UNITED STATES PATENT AND TRADEMARK OFFICE

APPLICATION NO.	FILING DATE	FIRST NAMED INVENTOR	ATTORNEY DOCKET NO.	CONFIRMATION NO.
10/761,955	01/21/2004	Nobuo Yamazaki	S011-5192	3878

Office Action Summary	Application No.		Applicant(s)	
	10/761,955		YAMAZAKI ET AL.	
	Examiner		Art Unit	
	Steven D. Maki		1733

FIG. 5

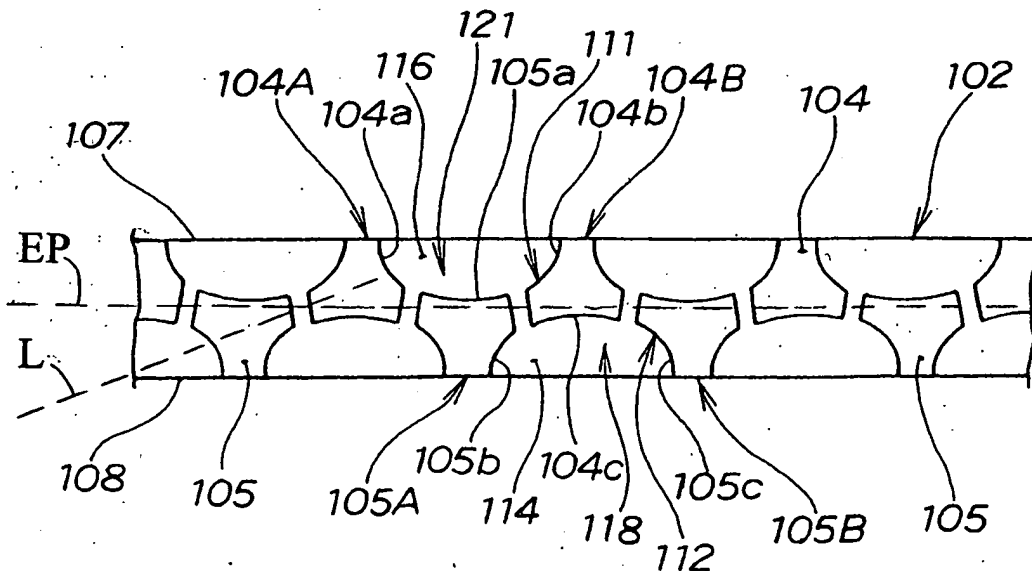
4) In view of the above new matter rejections, the proposed drawing correction for figure 5 has not been approved by the examiner (the selection of line L for defining the symmetry of the depressed portions being new matter).

Am 3-5-06
NOT APPROVED
